Subject: AP1000 COL Standard Technical Report Submittal

Pursuant to 10 CFR 50.30(b), APP-GW-GLR-044, Revision 0, "Nuclear Island Basemat and Foundation," Technical Report Number 85, is submitted as Enclosure 1 under the attached Oath of Affirmation.

APP-GW-GLR-044, Revision 0  
“Nuclear Island Basemat and Foundation”  
Technical Report Number 85

Figure 3.8.5-2 (Sheet 1 of 2)

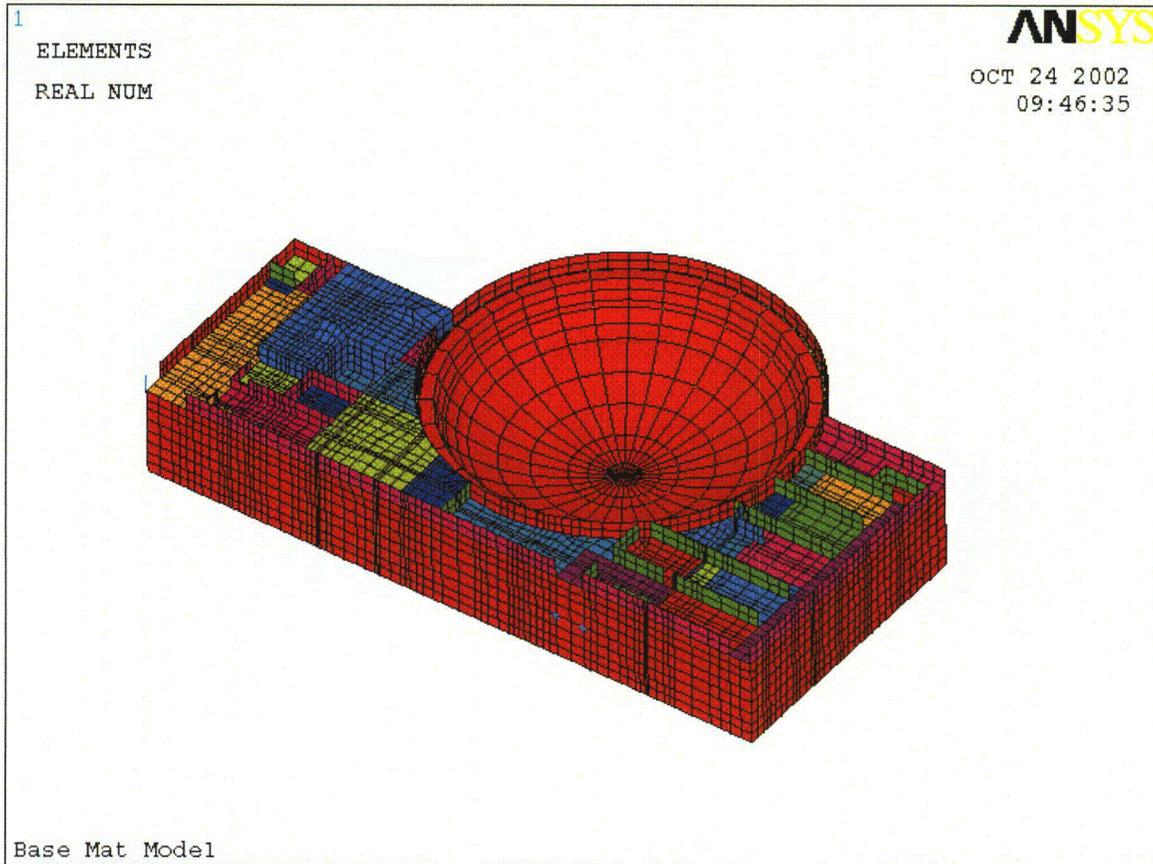
**Revise Figure 3.8.5-2 (Sheet 1 of 2) to Figure 3.8.5-2 and delete Figure 3.8.5-2 (Sheet 2 of 2)**

Figure 3.8.5-3 (Sheet 1 of 7)

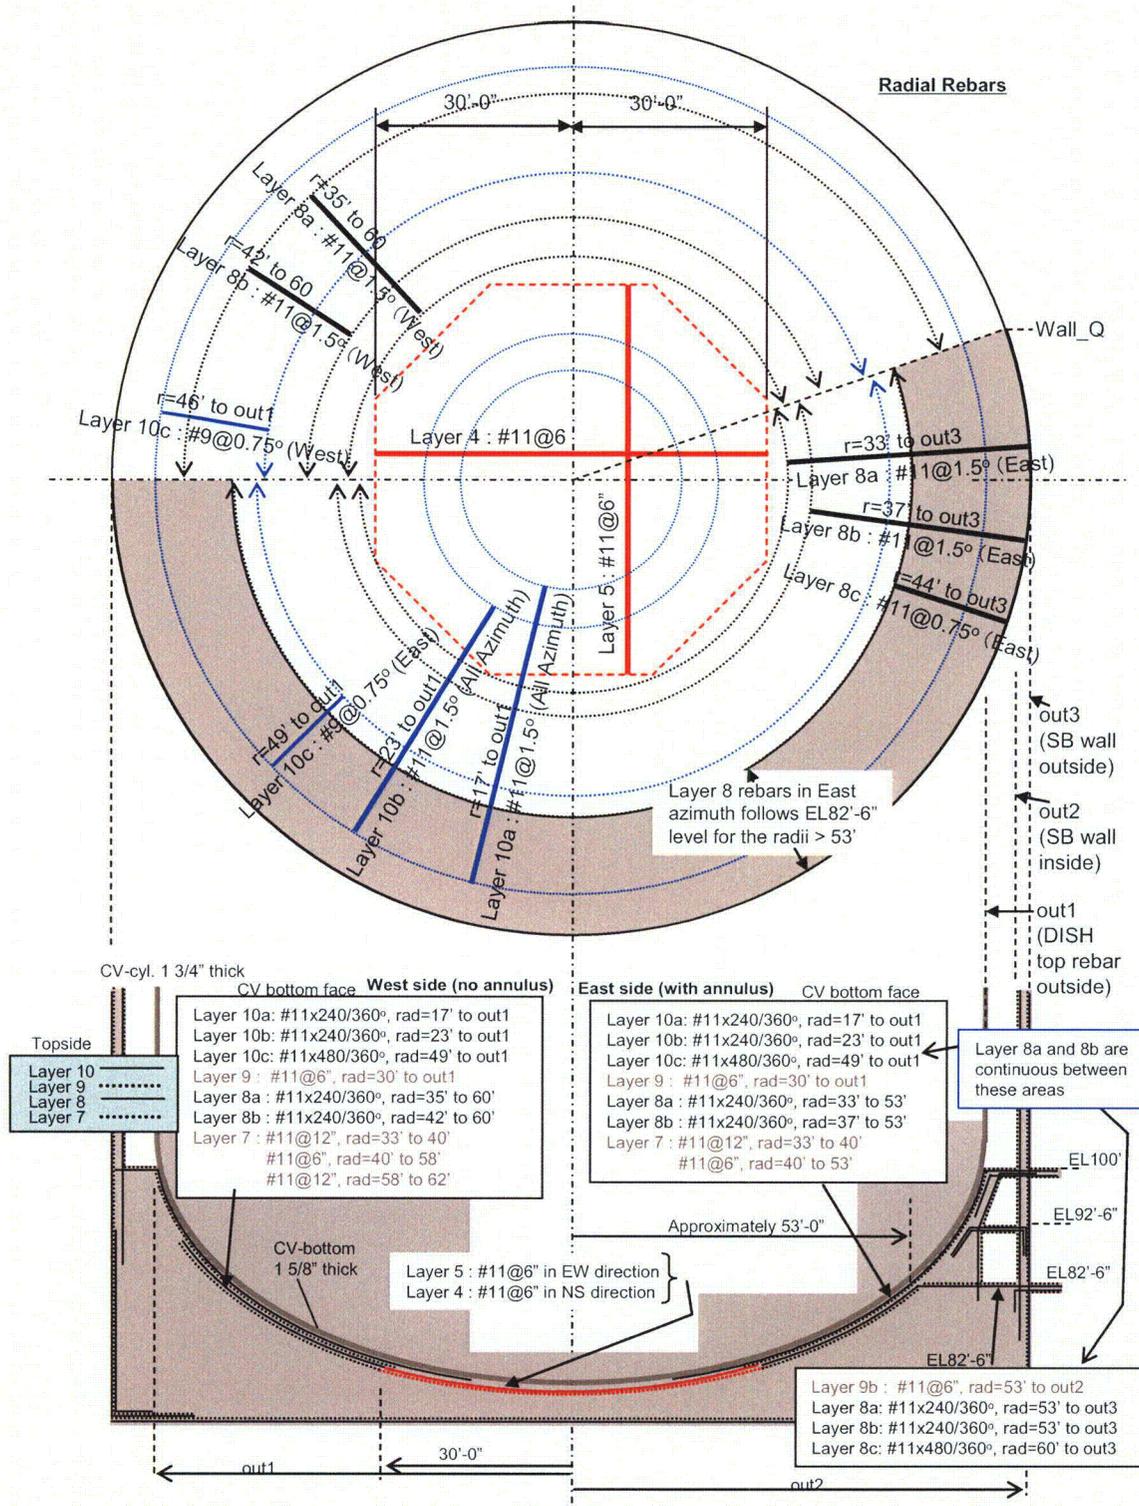
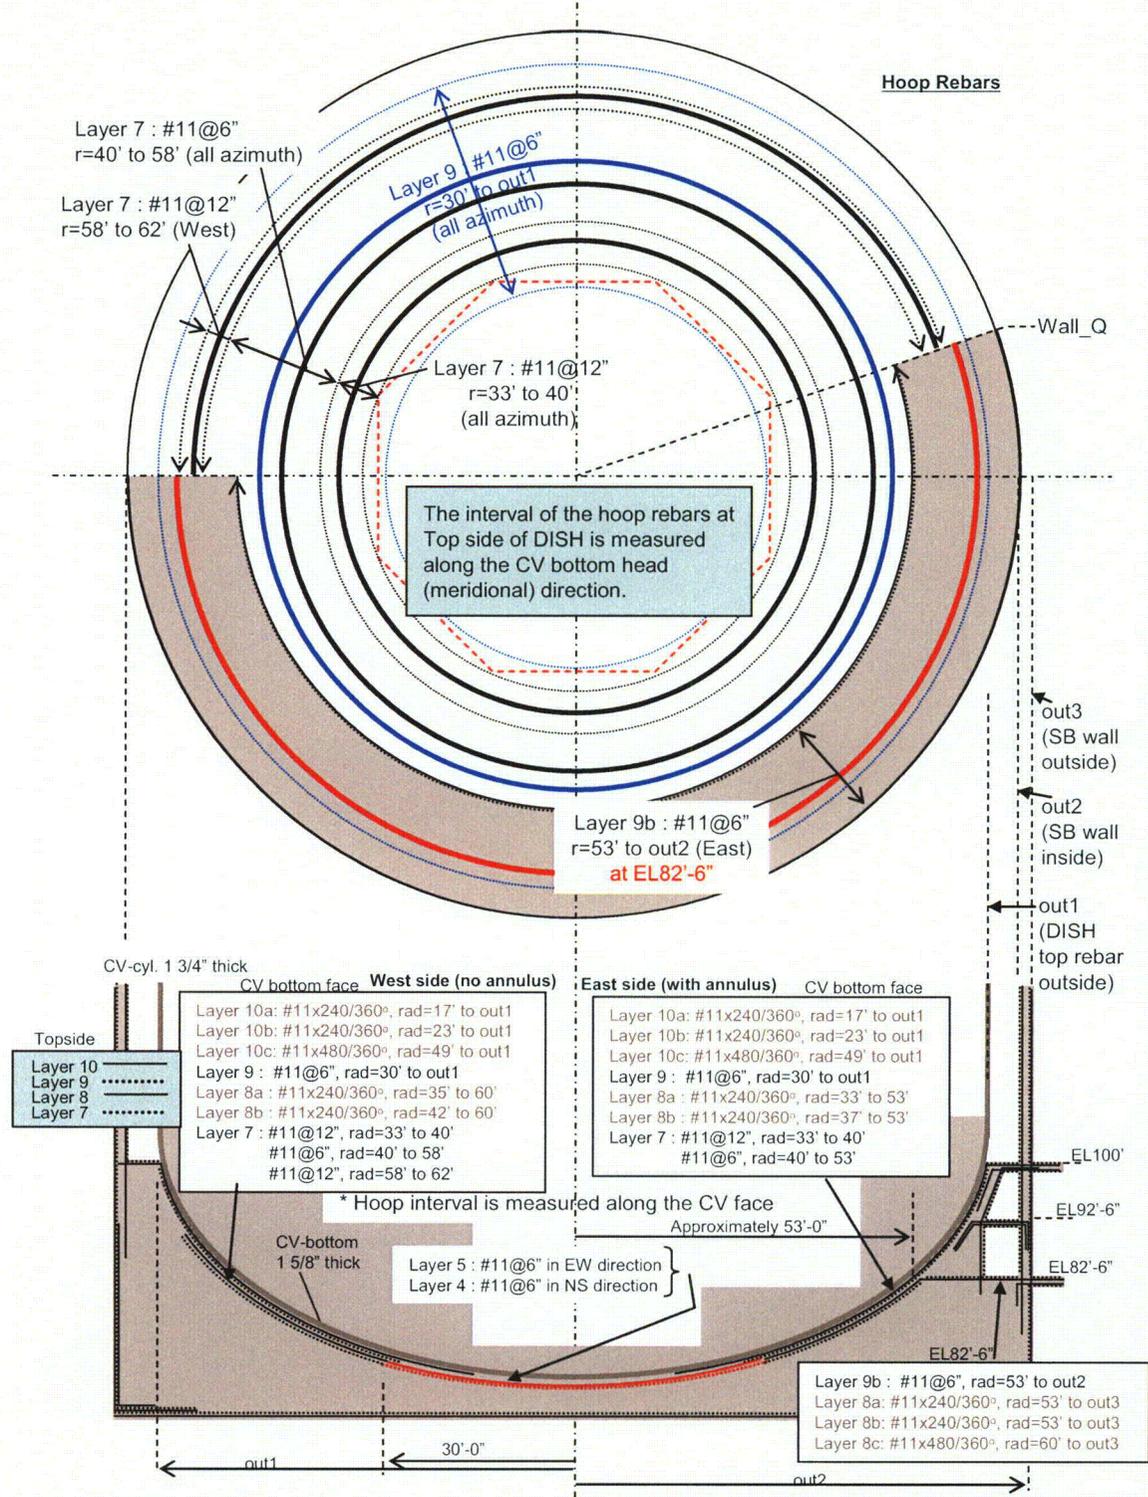
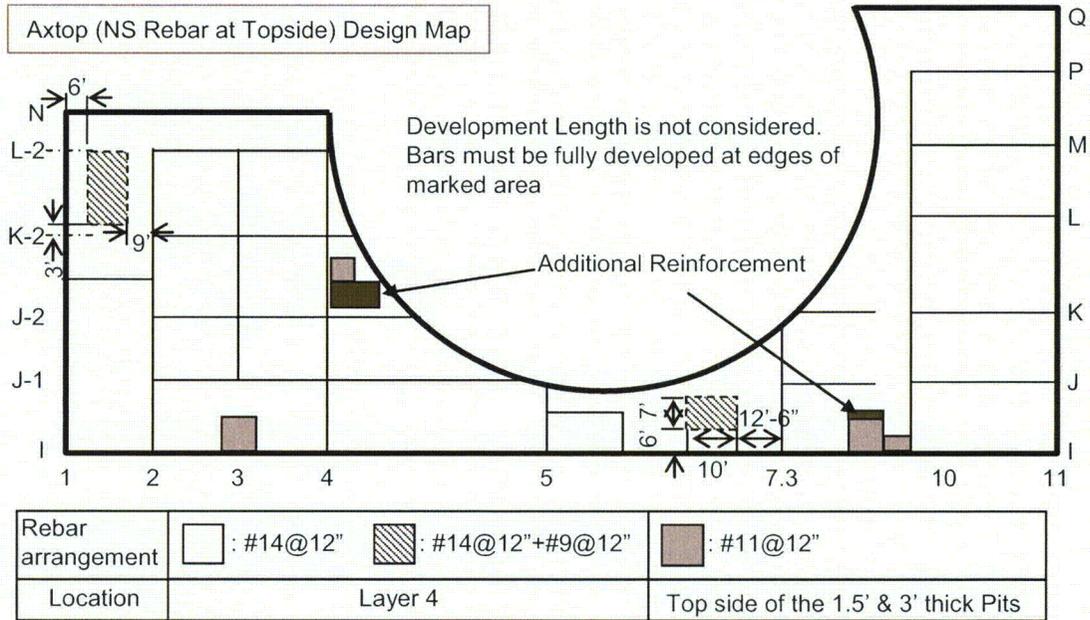
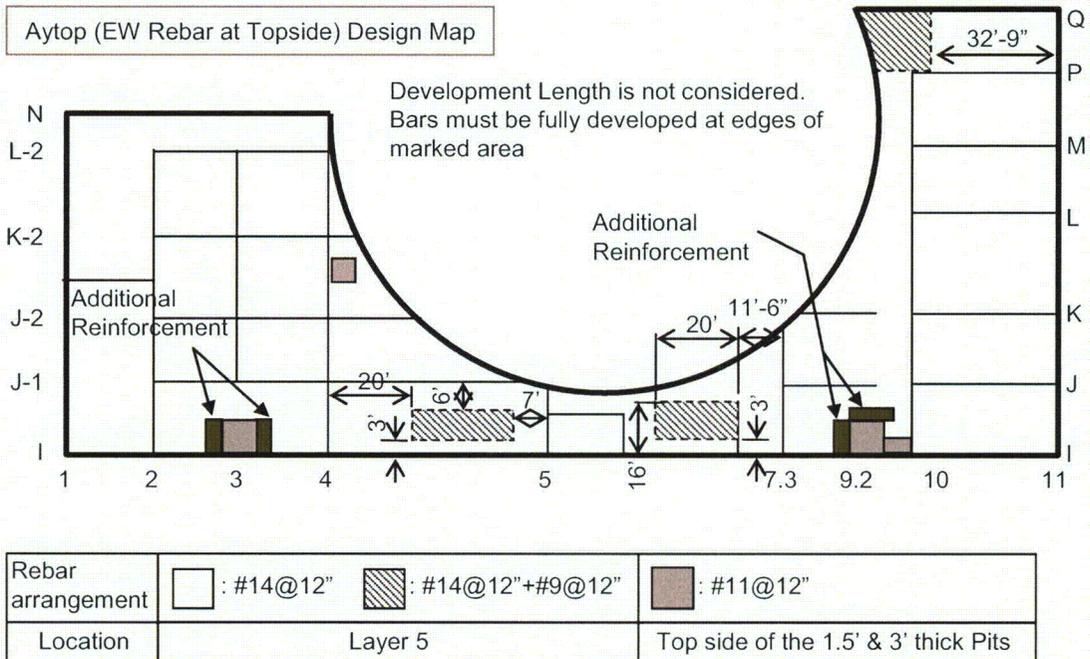
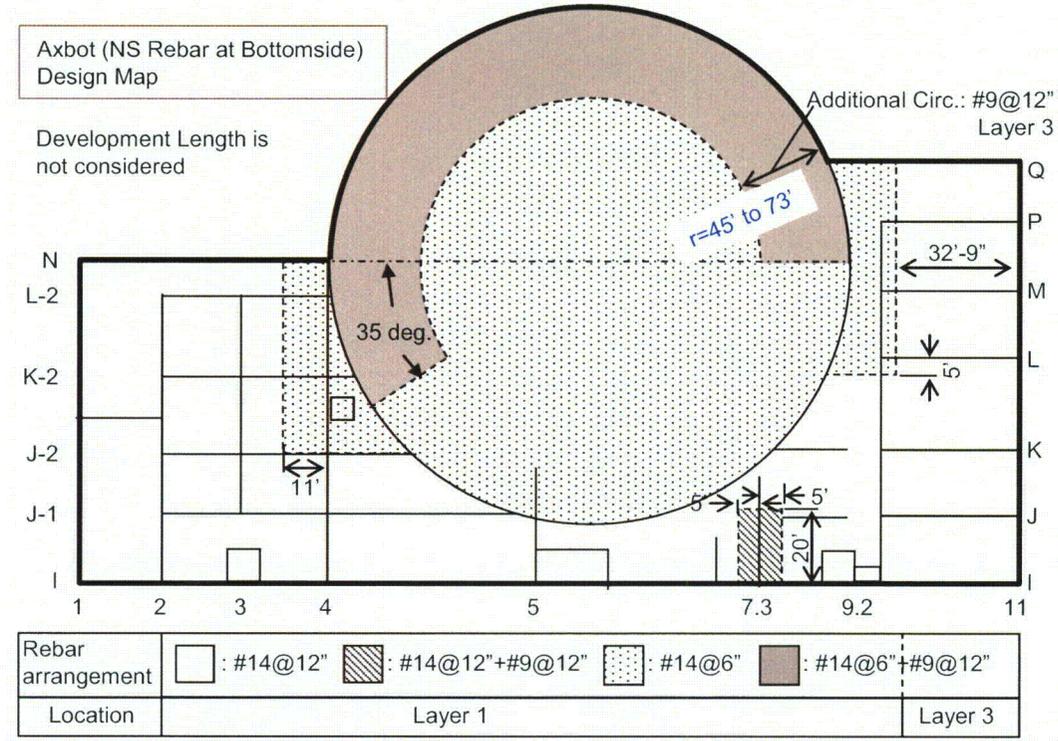
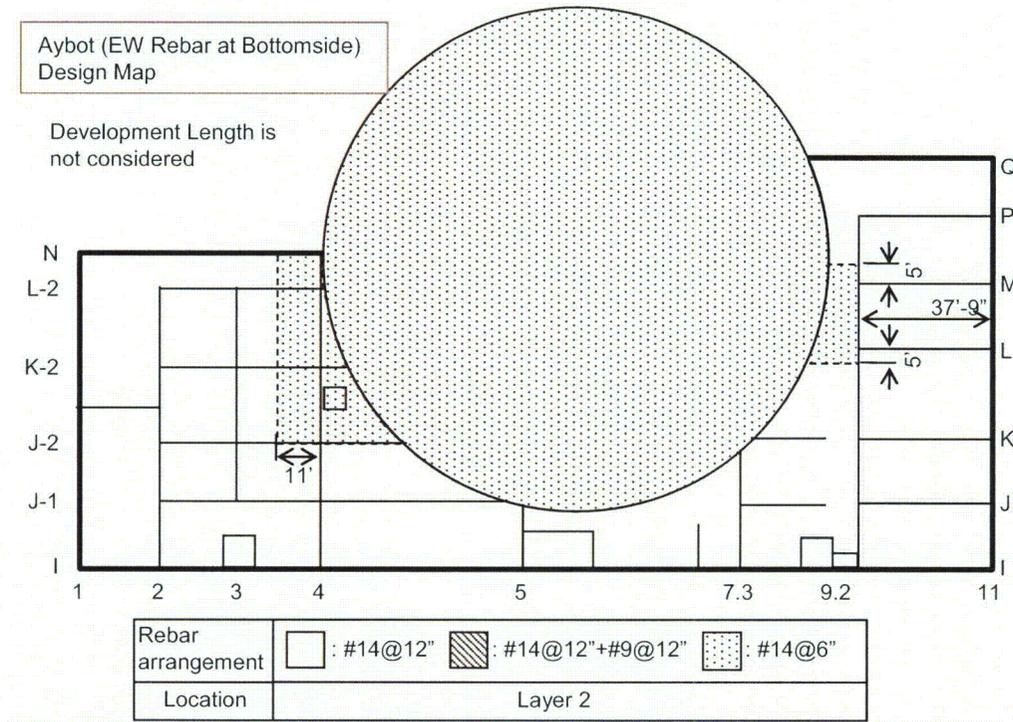
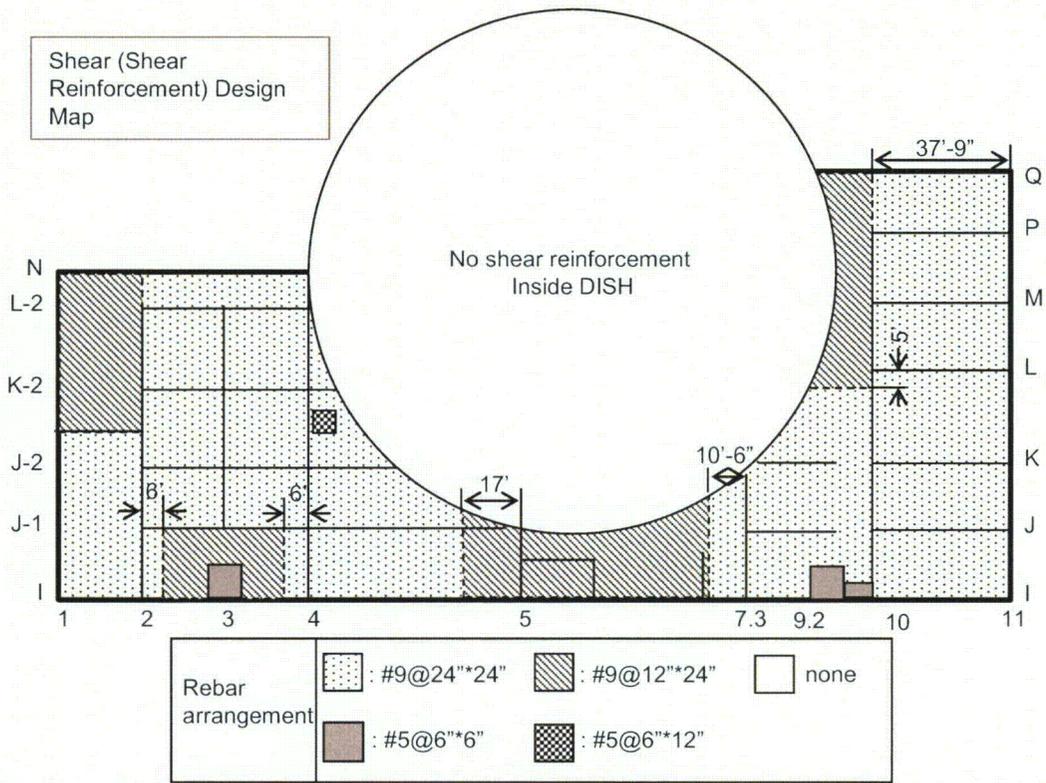
~~The required reinforcing steel for the portion of the basemat under the auxiliary building is calculated from shears and bending moments in the slab obtained from separate calculations. Beam strip models of the slab segments are loaded with the bearing pressures under the basemat from the three dimensional finite element analyses. Figure 3.8.5-3 shows the basemat reinforcement.~~

**Replace Figures 3.8.5-3 (5 sheets) by the following 7 sheets.**

The basemat is designed to meet the acceptance criteria specified in subsection 3.8.4.5. Two critical portions of the basemat are identified below together with a summary of their design. The boundaries are defined by the walls and column lines which are shown in Figure 3.7.2-12 (sheet 1 of 12). Table 3.8.5-3 shows the reinforcement required and the reinforcement provided for the critical sections.
